DATE: 02-26-2020

SUBJECT: ADDENDUM NO. 2 TO THE BIDDING DOCUMENTS FOR

**SUMMER 2020 H/LS IMPROVEMENTS**  
**EAST ALTON / WOOD RIVER HIGH SCHOOL**  
**EAST ALTON / WOOD RIVER CHSD NO 14**  
**WOOD RIVER, MADISON COUNTY, ILLINOIS**  
**HR # 150-2419**

A-301a

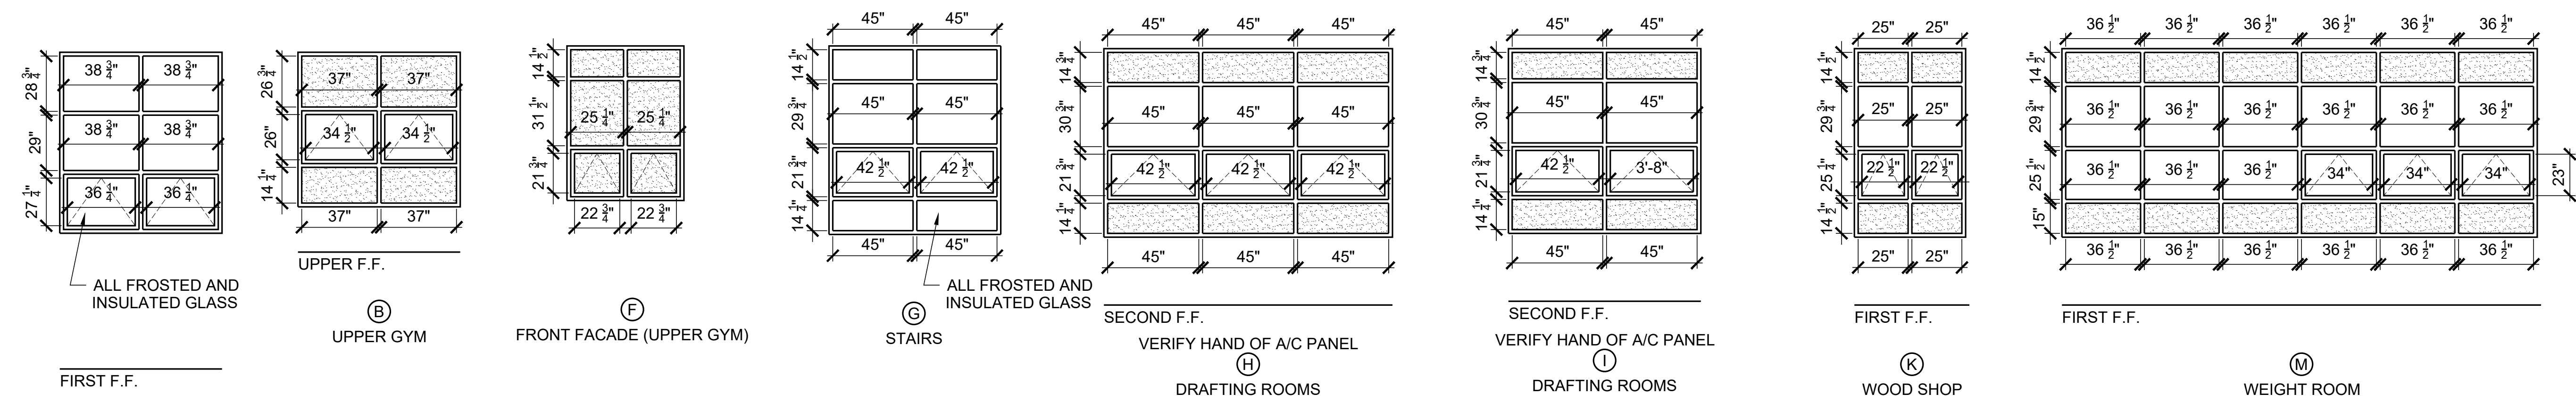
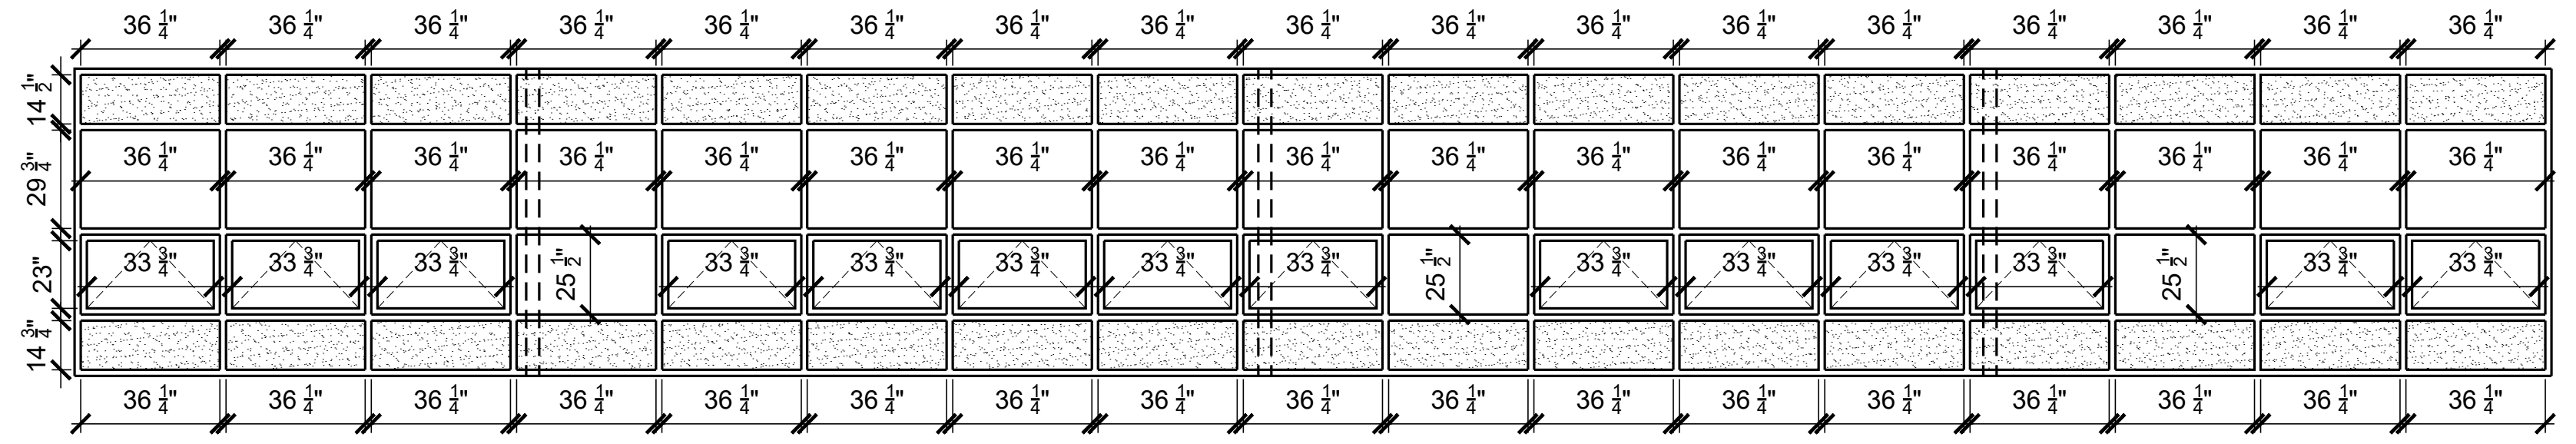
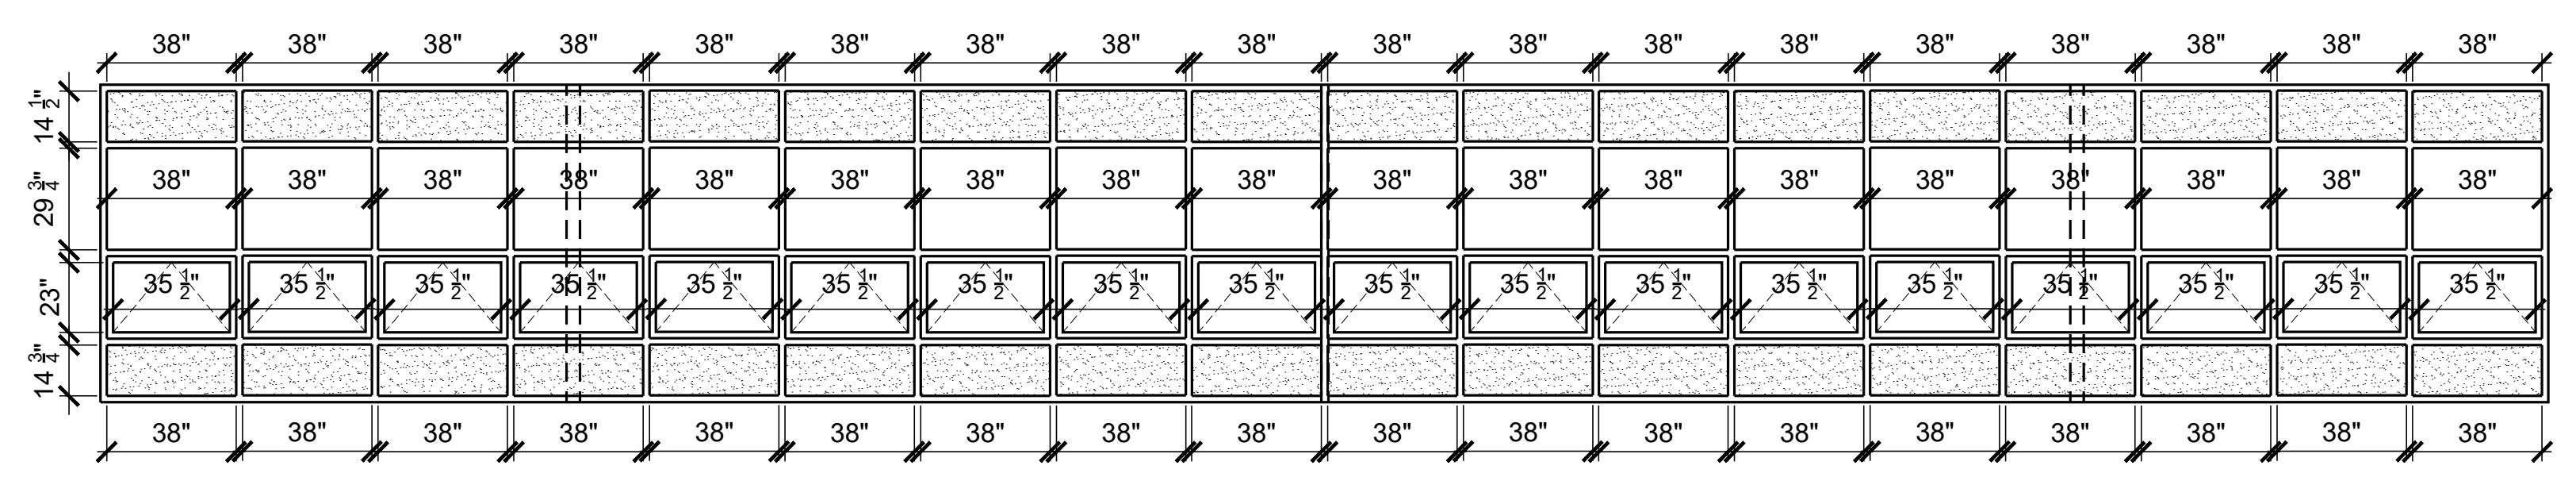
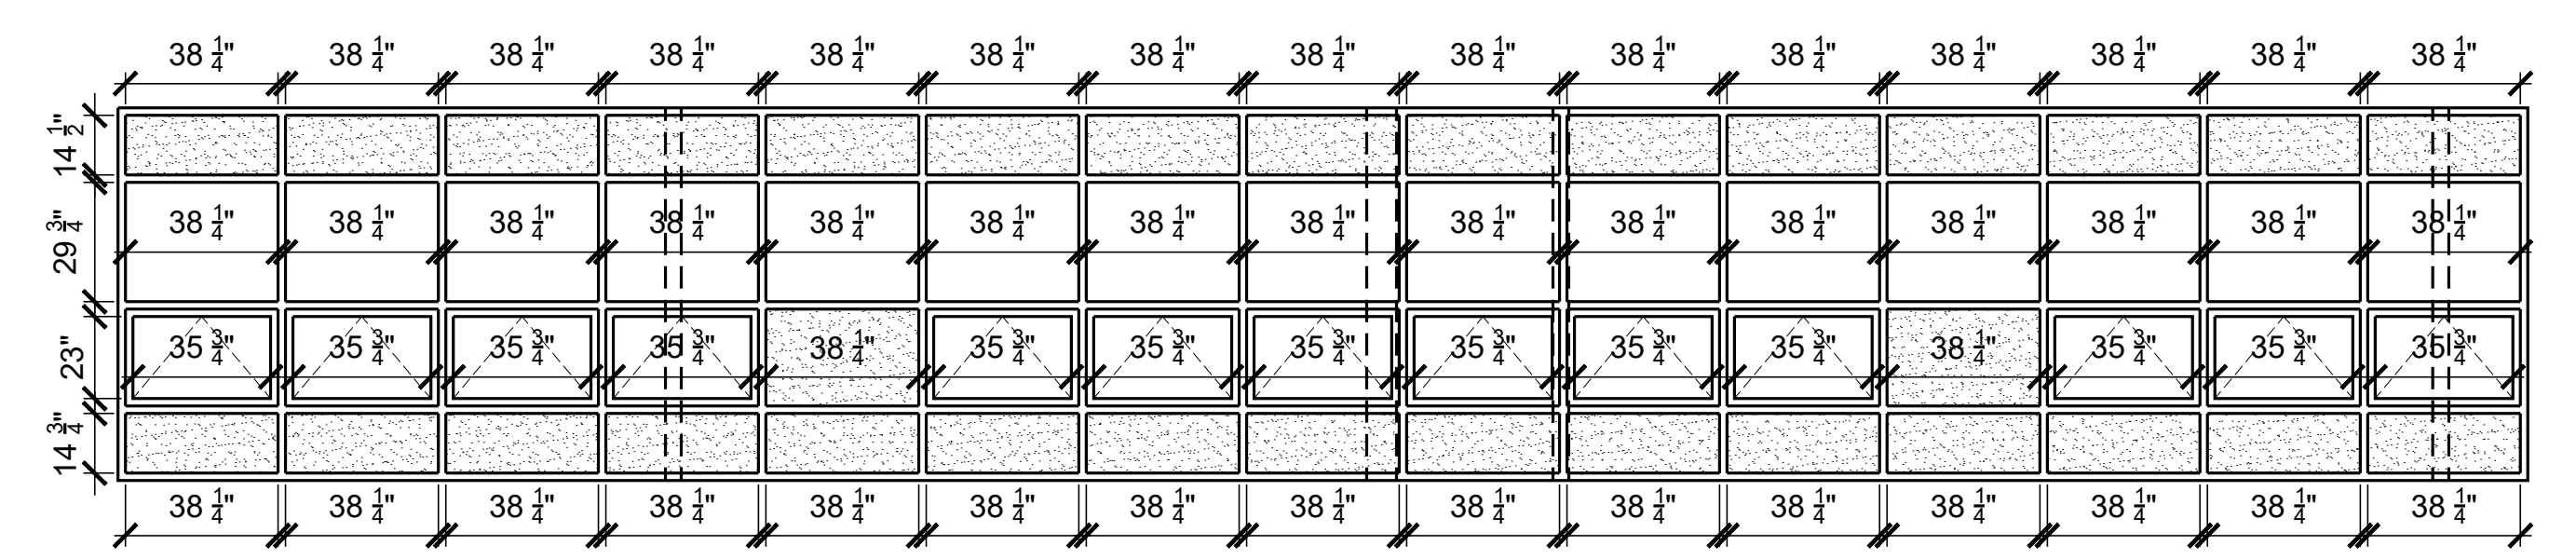
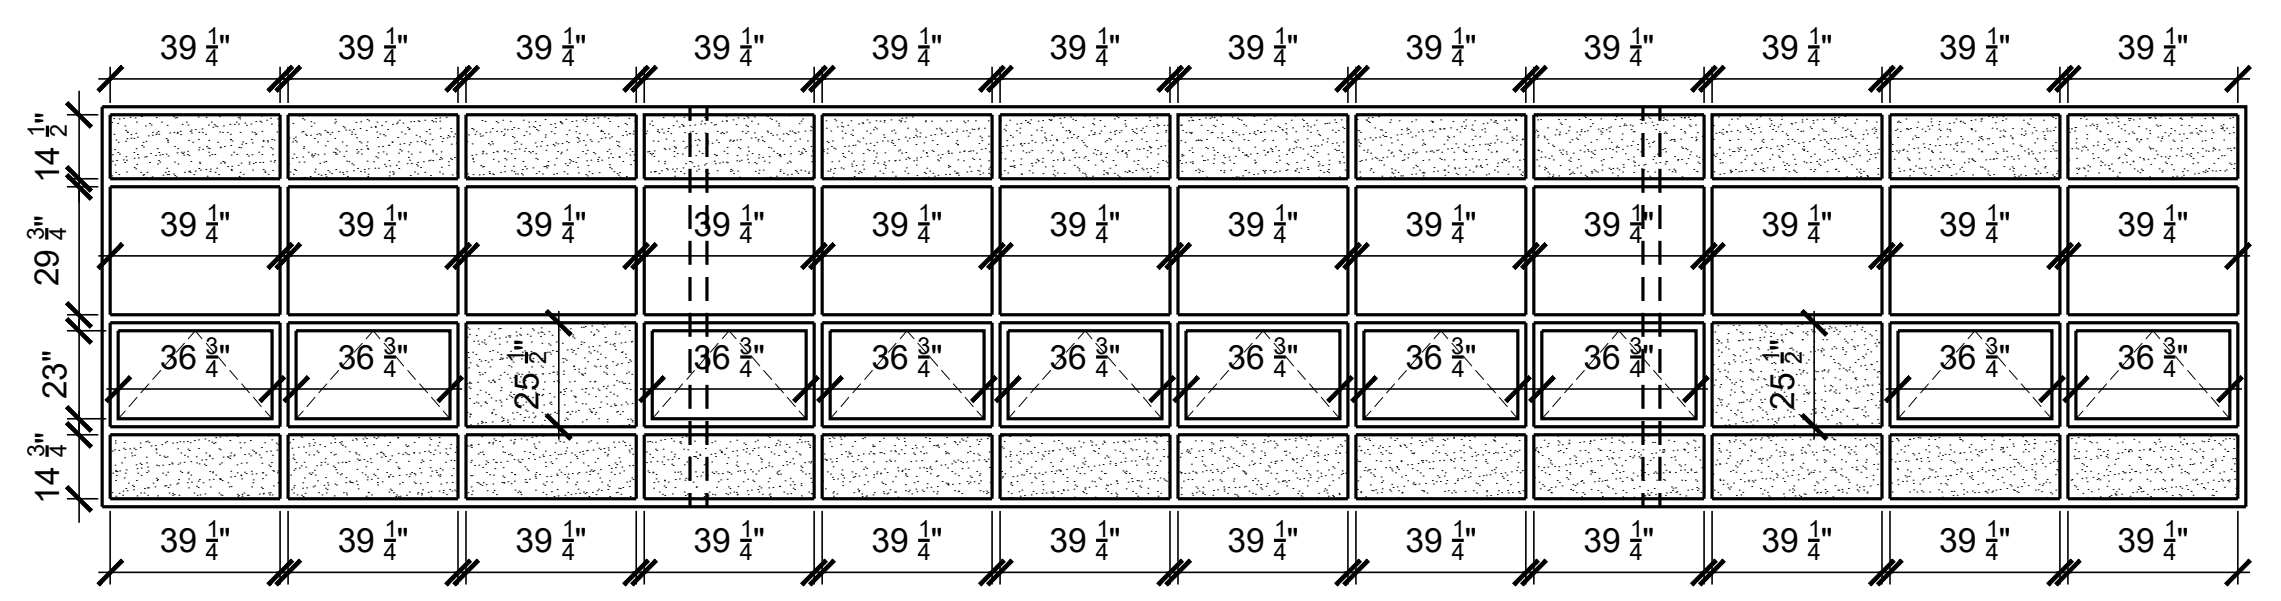
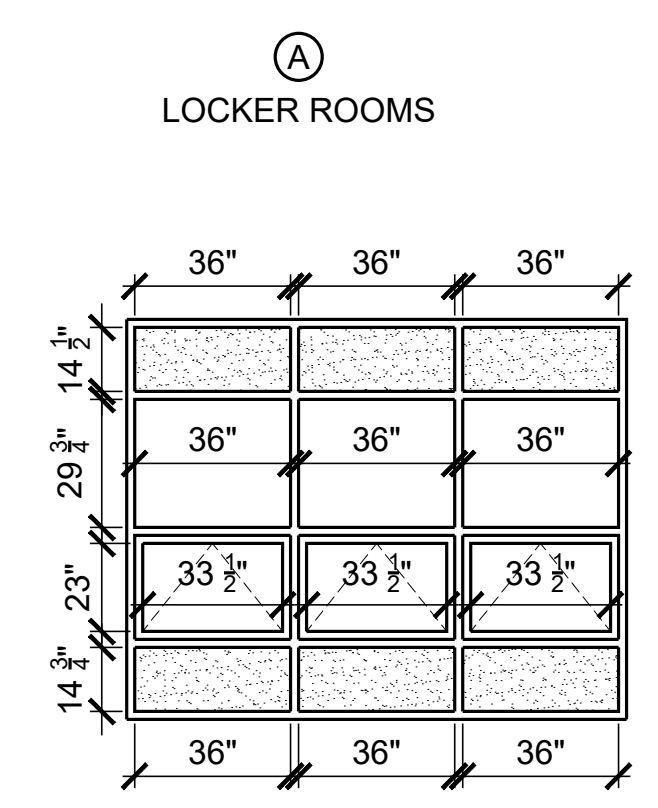
B. Sheet A-301a

1. **ADD** this sheet (Attachment #6) to the set of Drawings.
